Tech Tips

TT 61-08-05

2007- 2015 Eos – Convertible Top Repair Tip

July 29, 2016: Update to Information.

Figure 3b

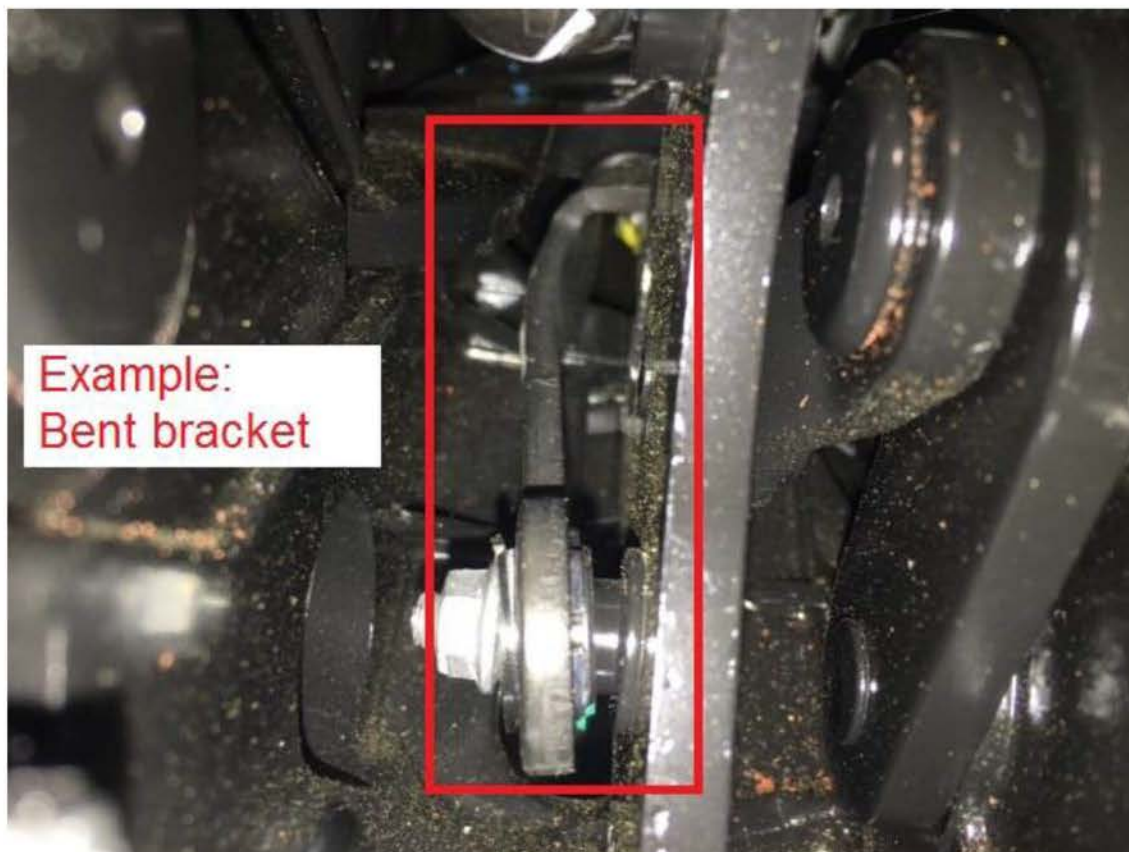
If, during diagnosis of the convertible top, the adjuster arm for the front lock is found damaged / bent (figure 3b), order part number 1Q0898499 or latest supersession. This one part number will include both sides in the package. Adjuster arm location is shown below with painted roof pillar panel removed. Adjuster arm can be found bent on either or both sides of the vehicle. If adjuster arm is found to be bent, review Tech Tip 2032328 (TT 61-07-105) as a failed side rail latch could be the cause.
